# Access Compliance Report Public Rights-of-Way (Curb Ramps)

| Intersection ID: N/A | Main Street: MORABLIN_DR | Cross Street: MERSINGTON_LN | Location: NE                                 |
| ADA ID: E712FD2A0DDA | Ramp Type: PerpDiag      | Initial Pass/Fail: Pass     | Overall Compliance: No<br>Severity Score: 15 |

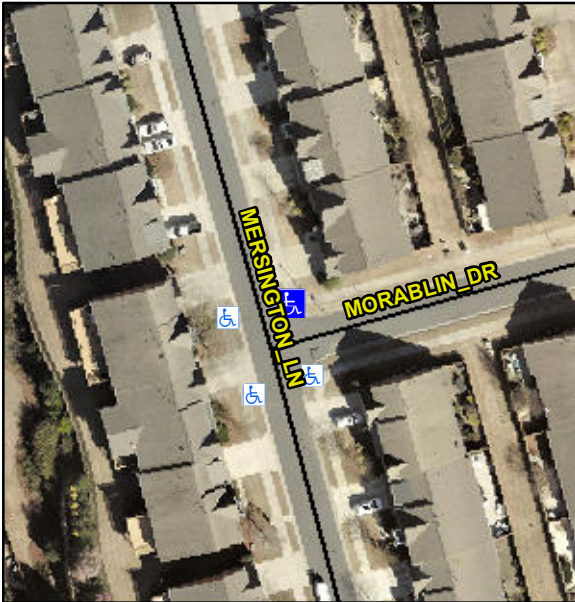
**R304.2.2-Perp, R304.3.2-Para, R305, R304.5.4**

| Compliance | Description           | Data   | Compliance | Description                 | Data |
|------------|-----------------------|--------|------------|-----------------------------|------|
| Yes        | Landing Length (in)   | 59.0   | No         | DWS Provided?               | No   |
| No         | Landing Slope (%)     | 3.8    | N/A        | DWS Length (in)             | N/A  |
| Yes        | Gutter Ponding?       | No     | No         | Gutter Slope (%)            | 6.4  |

**Remove & Replace Curb Ramp With Two New Directional Ramps or Equivalent. Remove & Replace Gutter.**
